United States Nuclear Regulatory Commission  
Washington, D. C. 20555

Subject: Revised Responses to 210 Series RAIs; (Mechanical Engineering  
Branch)

SB 1 & 2  
FSAR

Figure 3.6(N)-2

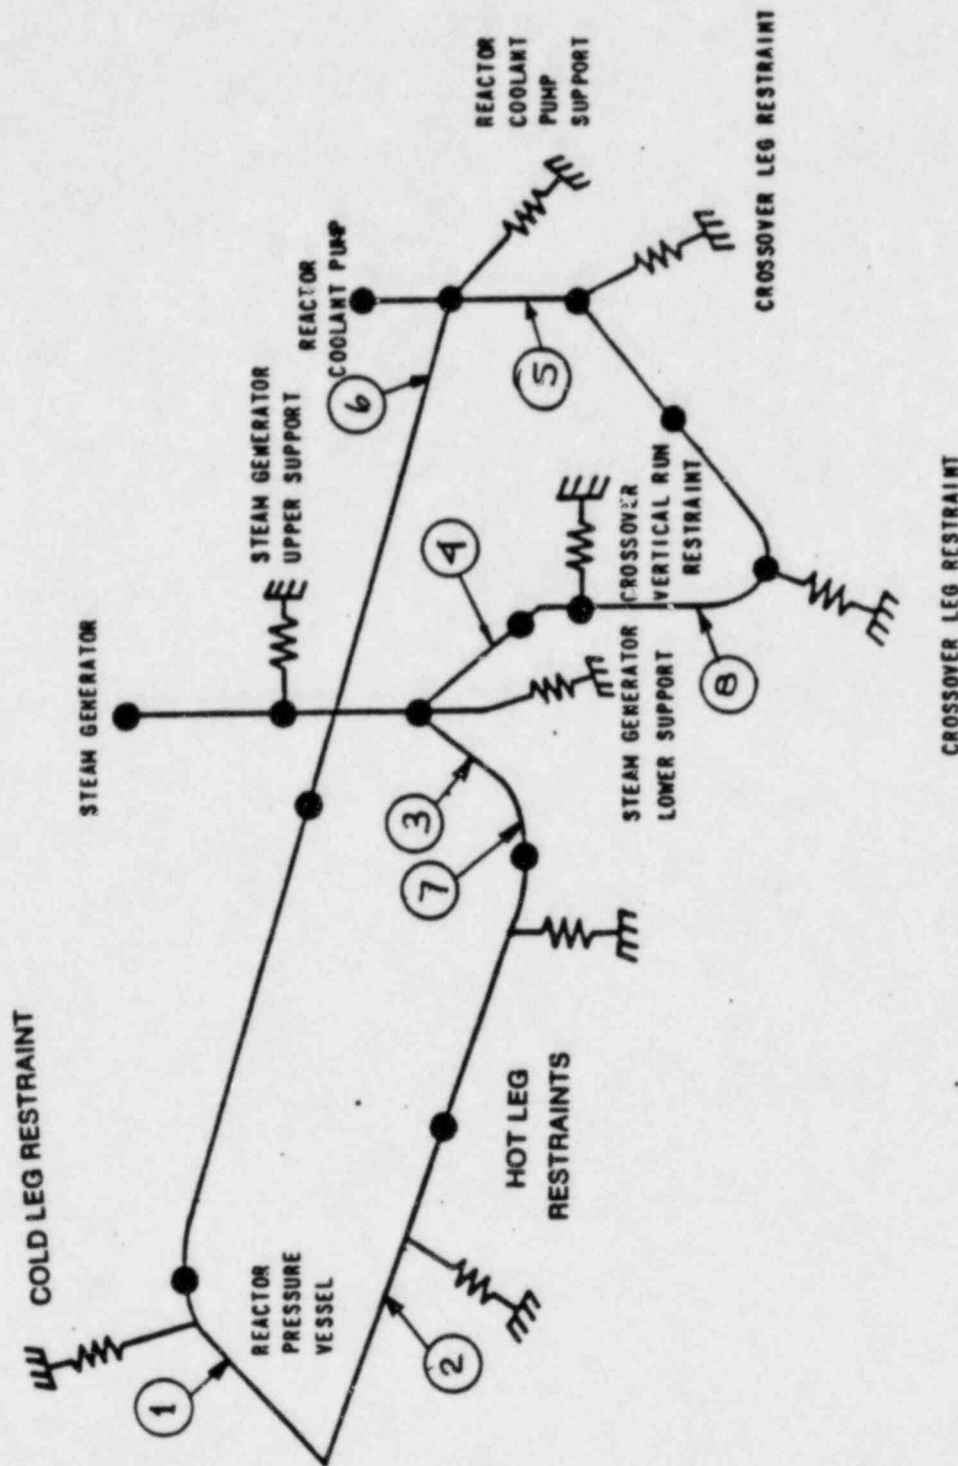
RAI 210.24 (3.6(N).2.5, Figure 3.6(N)-2)

Break opening areas, are discussed in detail in the response to RAI 210.21. Additionally, the location of pipe whip restraints in the RCS was also discussed. ~~Westinghouse agreed to review Figure 3.6(N)-2~~ to clearly indicate the location of pipe whip restraints in the RCS. Additionally, the revised figure ~~will~~ indicate the correct location for break No. 8 in the RCS.

{ A new figure 3.6(N)-2 has been incorporated  
in FSAR Amendment 47
